SIB 61 06 15

## Washer Fluid Reservoir Rattles While Driving on Rough Roads

This Service Information Bulletin (Revision 3) replaces SI B61 06 15 **dated August 2017**.

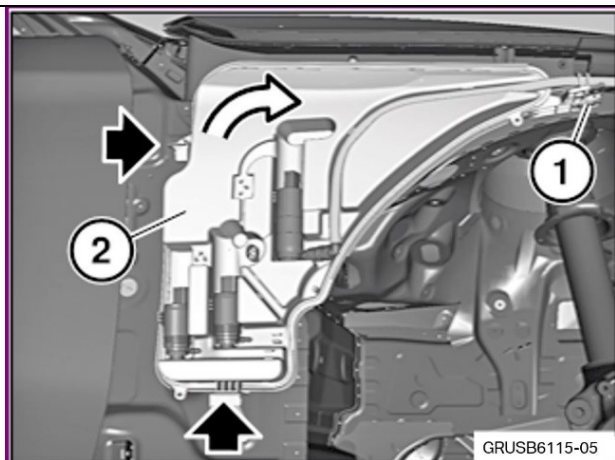
Rattling noises heard from vicinity of glove box.

The windshield washer reservoir upper plastic locating guide tab has too much lateral play.

Apply a piece of self-adhesive felt tape to the upper plastic locating guide of the washer fluid reservoir.
